SB0008

Pozor, čtěte – důležité!

Attention, read – important!

PU0079/KS 7.04193.02.0

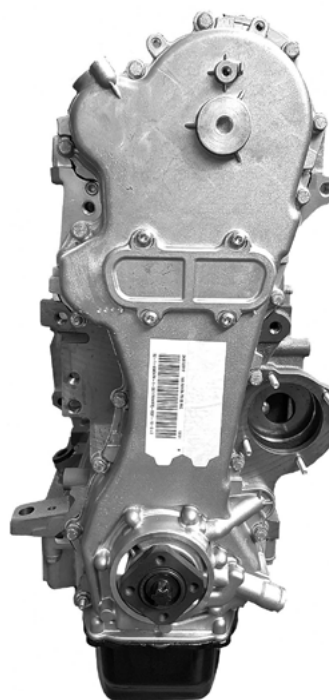
The SB0008 engine contains an oil pump without sensor OE: 55232196 (also matches PG 7.04193.02.0 and ET PU0079).

Olejové čerpadlo bez senzoru.
Oil pump without sensor.
Ölpumpe ohne Sensor.

If this engine is installed in a vehicle which originally used an engine that contained an oil pump with sensor, it is necessary to replace the oil pump with number 55268633 (also Pierburg 7.03903.03.0 and ET PU0119).

Olejové čerpadlo se senzorem.
Oil pump with sensor.
Ölpumpe mit Sensor.
